NOTICE OF ADDENDUM ADDENDUM NO. 1

CONTRACT NO. 8191, PROJECT NO. 11743 N. BLACKHAWK AVENUE, BRUCE COURT, AND HEATHER CREST RESURFACING WITH UTILITIES ASSESSMENT DISTRICT – 2018

Insert Sheets SN1-SN5, SN-9 (Revised 5-18-18)

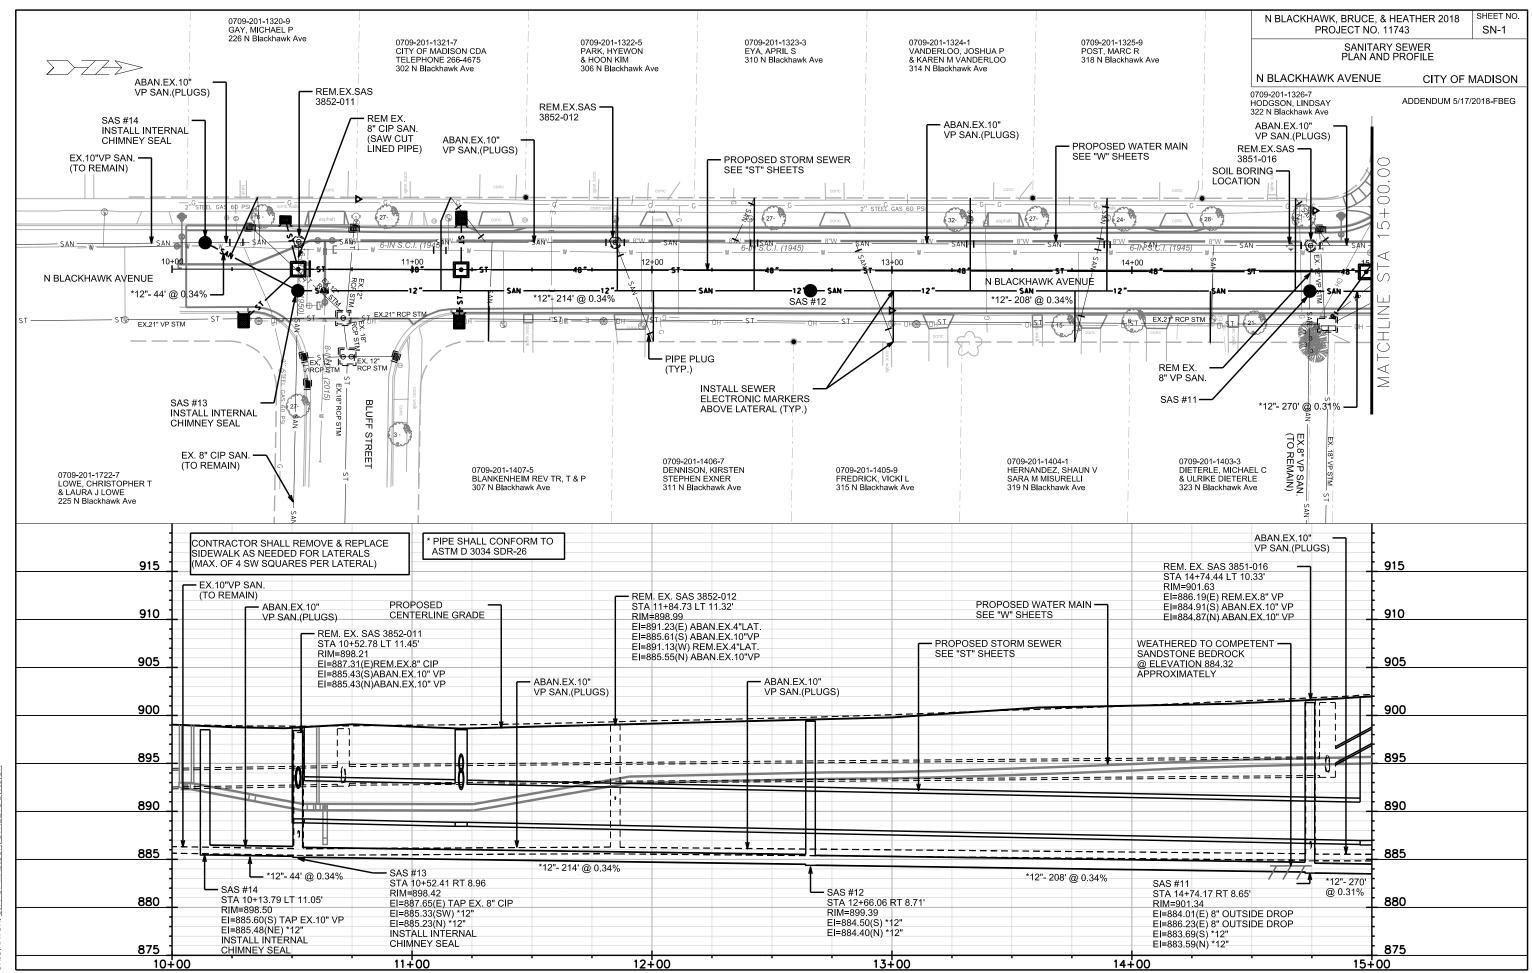
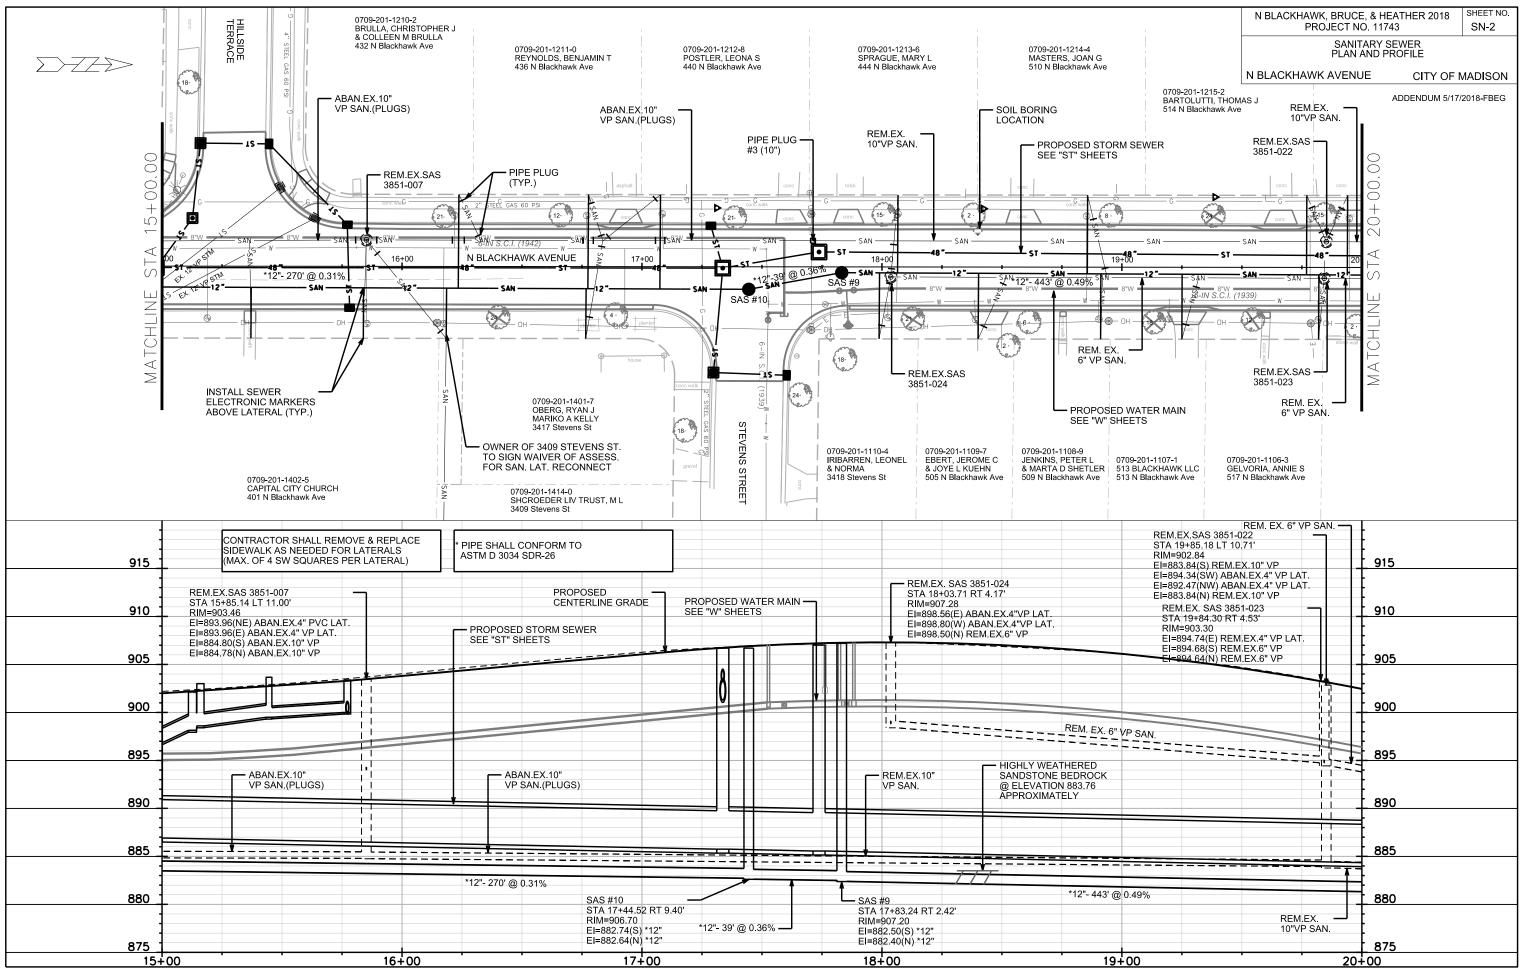
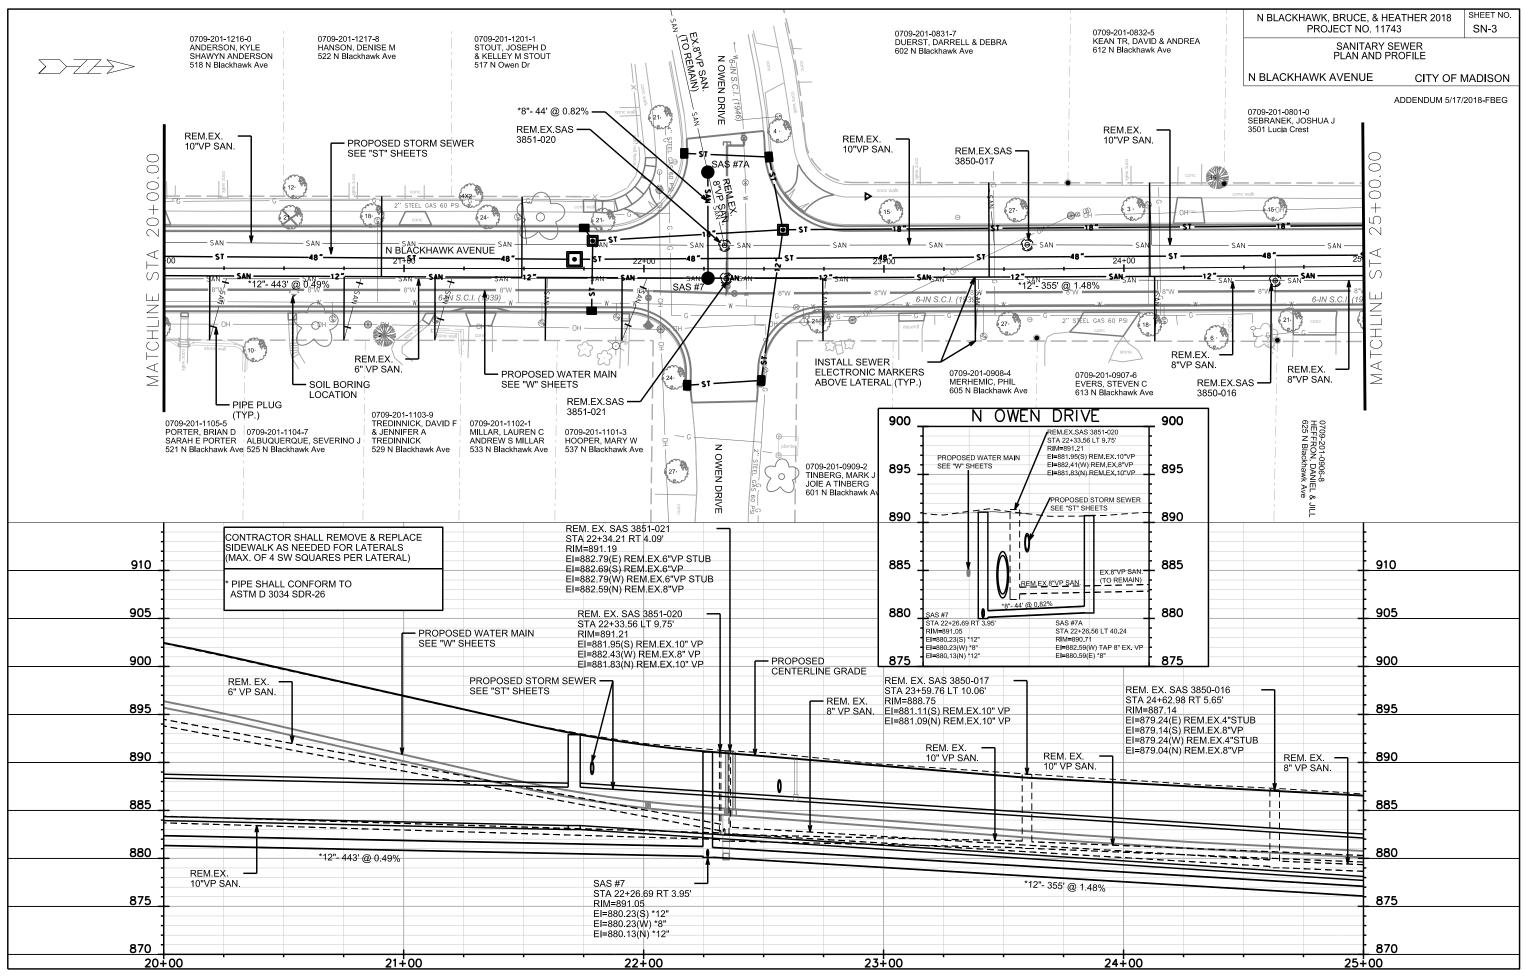
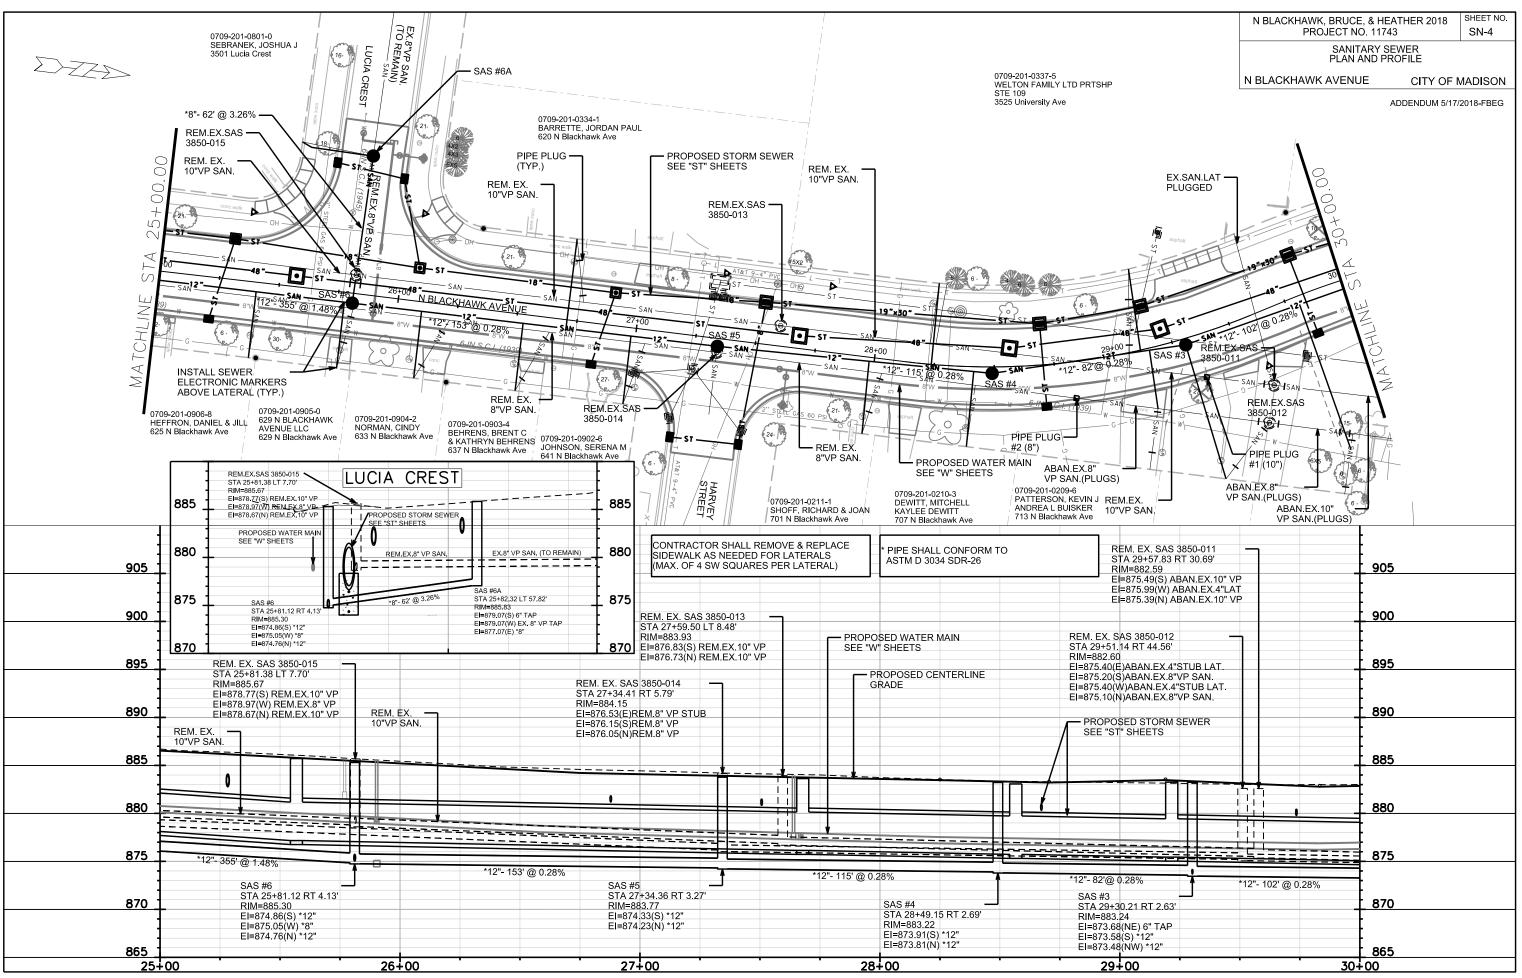
Proposed sanitary sewer main on N Blackhawk Street is upsized from 10" to 12". No changes in pipe length or pipe depth were made.
